**Town of Kittery  
Planning Board Meeting  
January 11, 2024**

**ITEM 3 – 15 Bowen Road– Shoreland Development Plan Review**

Action: Accept application. Approve plan or continue review: Pursuant to §16.9.3 Shoreland Development Review of the Town of Kittery Land Use and Development Code, Nicole Sanborn, on behalf of owner/applicant Eric Dyer, requests approval to stabilize 86 linear feet of existing eroding shoreline with riprap along the property of 15 Bowen Road, Tax Map 17, Lot 4, in the Residential-Urban, Shoreland Overlay, and Resource Protection Overlay Zones.

PIER STRUCTURE REPLACEMENT PLAN	
ON LAND LOCATED AT 15 BOWEN ROAD, KITTERY, YORK COUNTY, MAINE	
PREPARED FOR:	RIVERSIDE & PICKERING MARINE CONTRACTORS, 34 PATTERSON LANE, NEWINGTON, NH 03801
JOB #:	23-114
DATE:	SEPT. 11, 2023
SCALE:	1" = 10'
SHEET:	1 OF 2

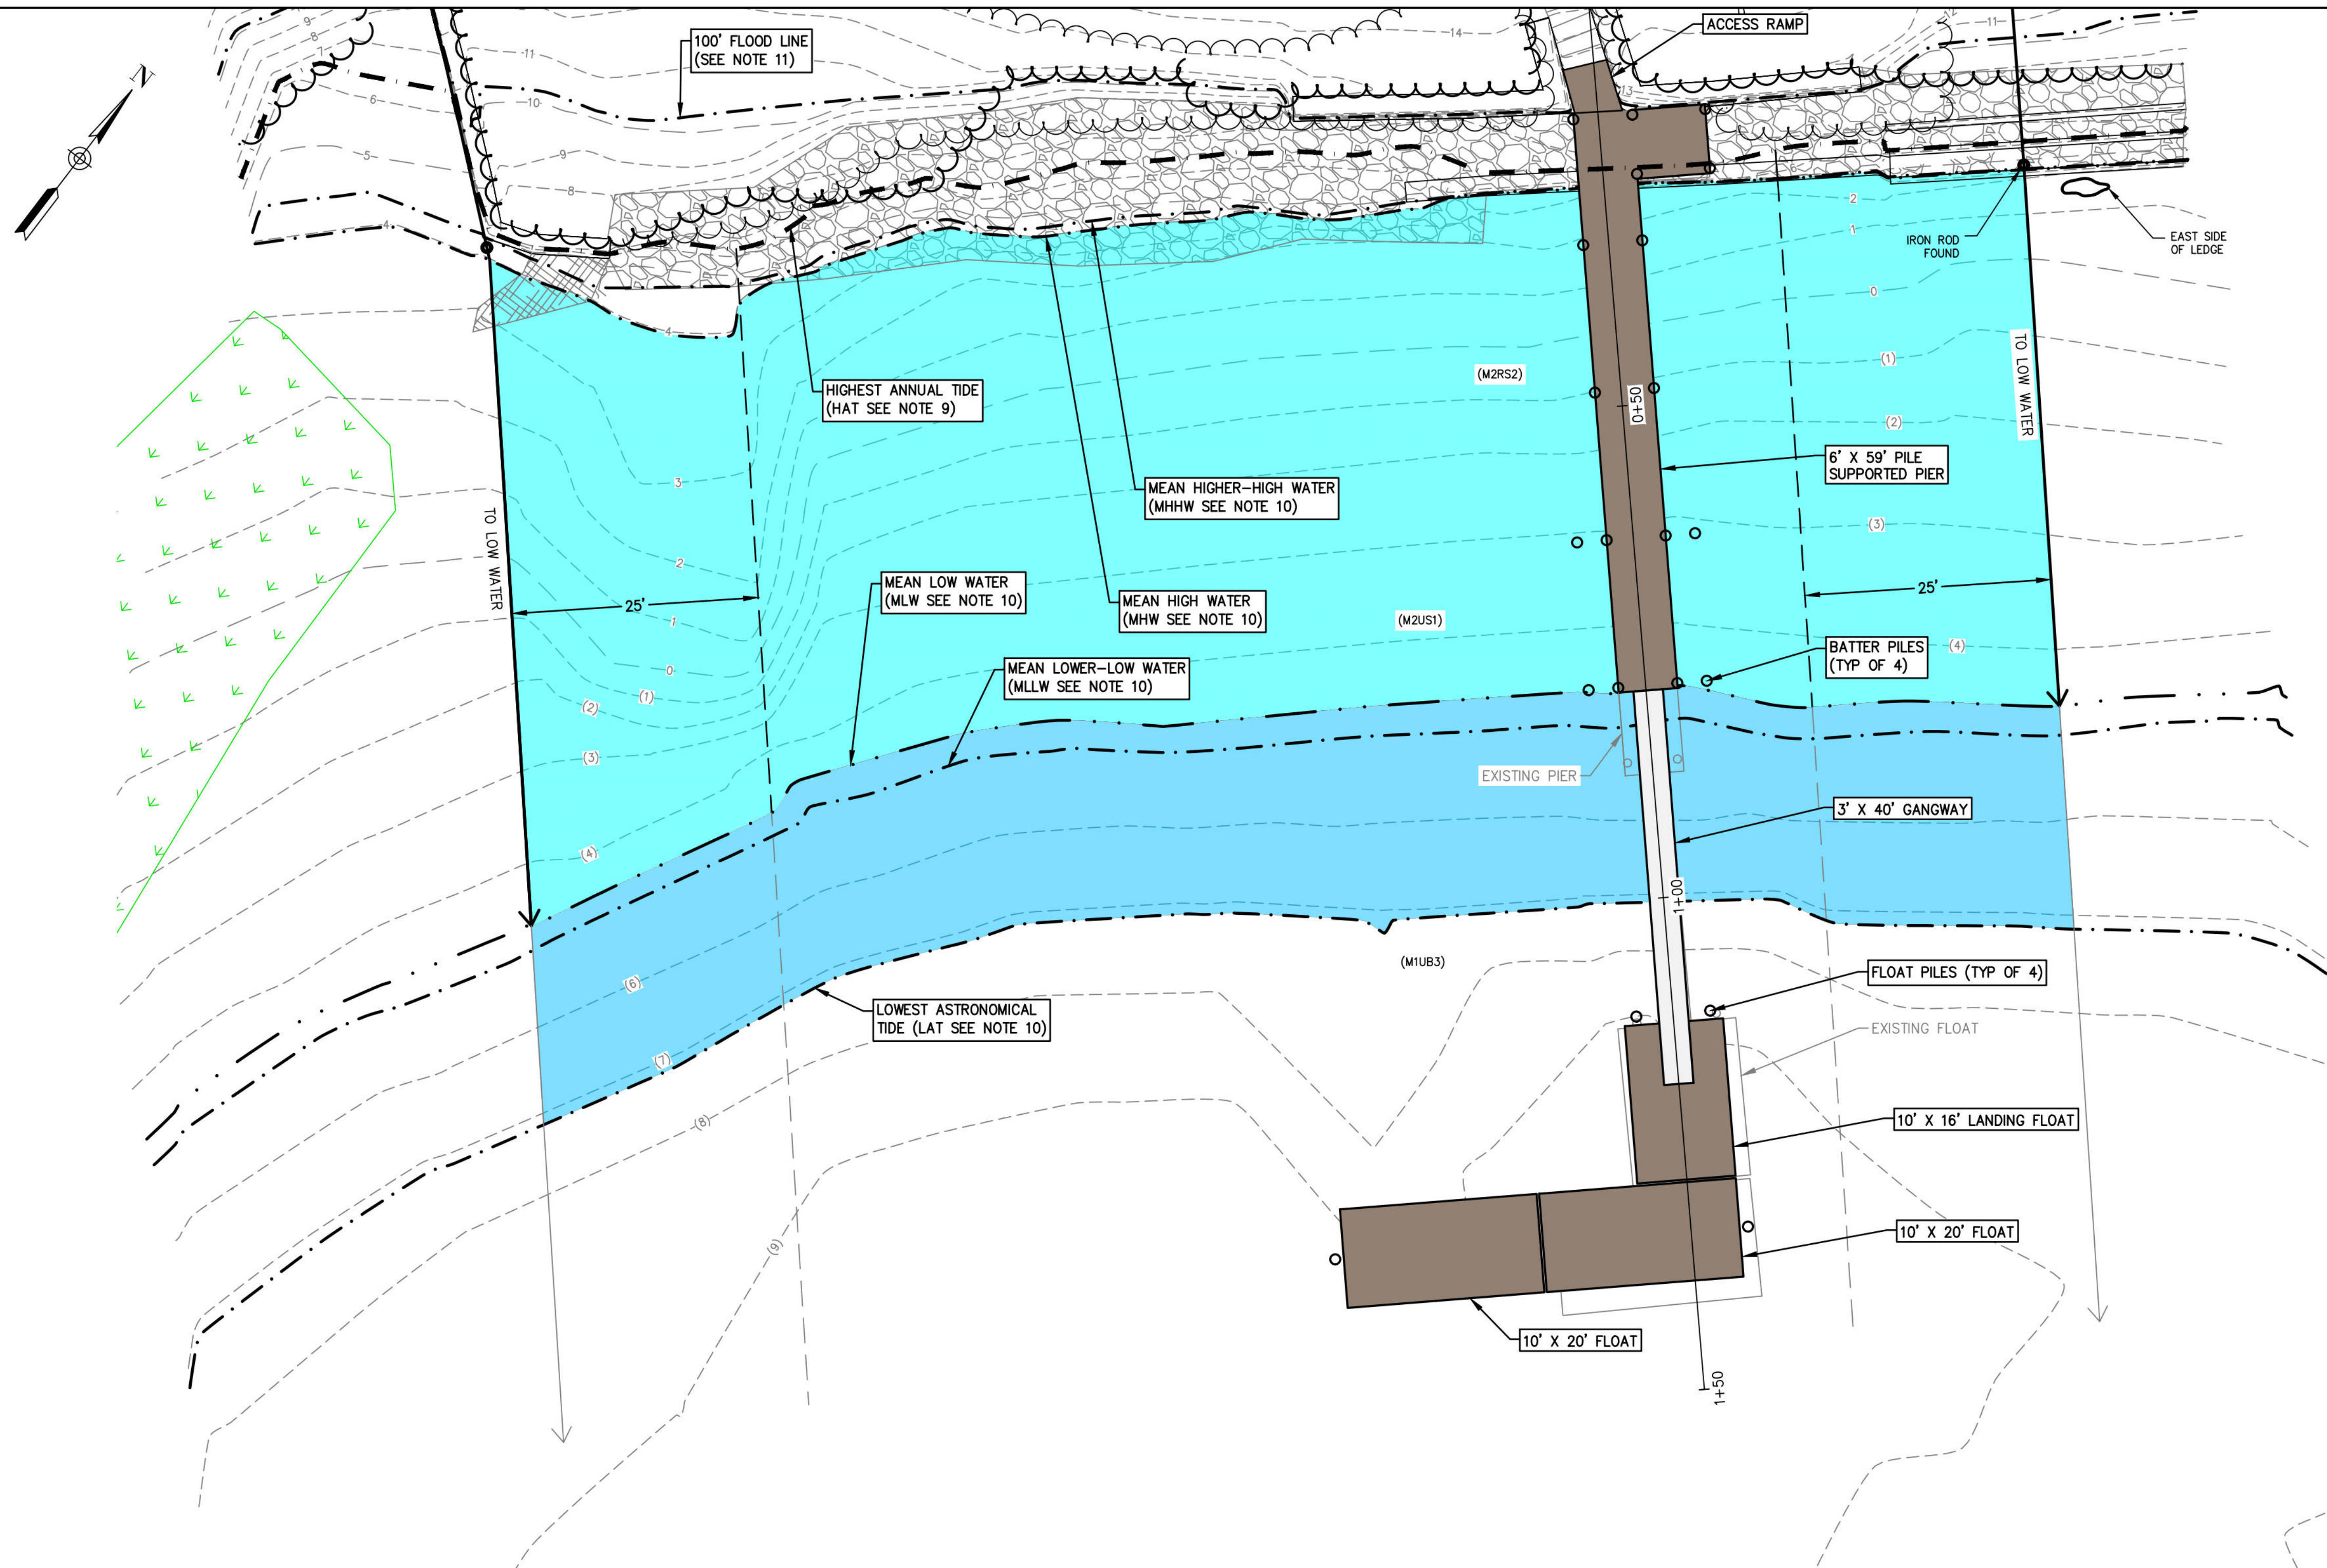
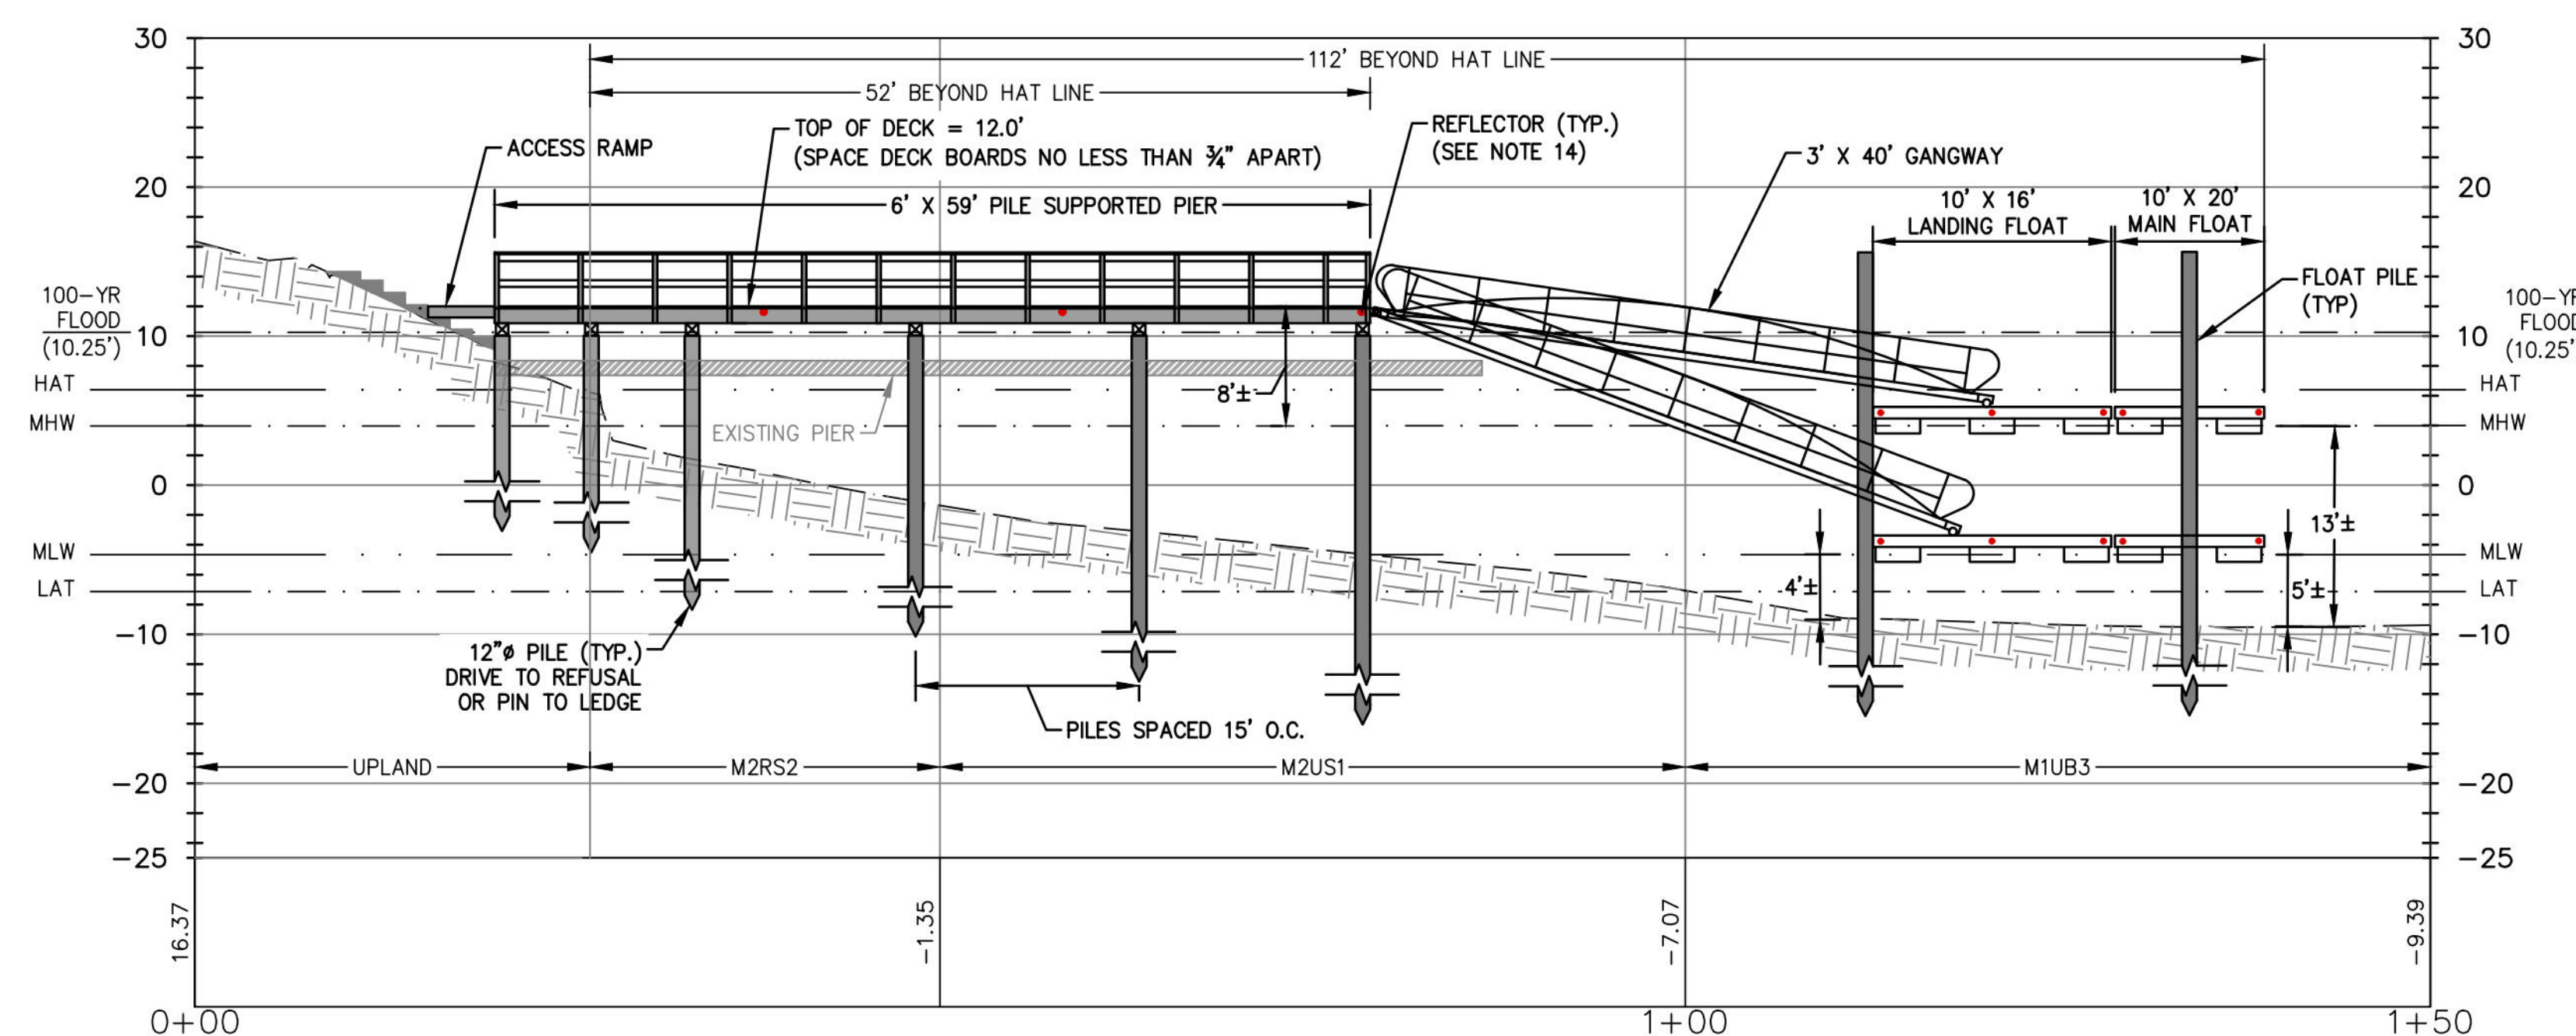
- 54 a. The proposed float replacement is under the jurisdiction of Kittery Port Authority. Water-  
55 dependent uses, such as floats, have a 0-foot setback from any water bodies.

- 64 b. The portions of the float above the HAT line are being replaced in-kind with the same  
65 dimensions, and therefore do not increase devegetation of the lot.
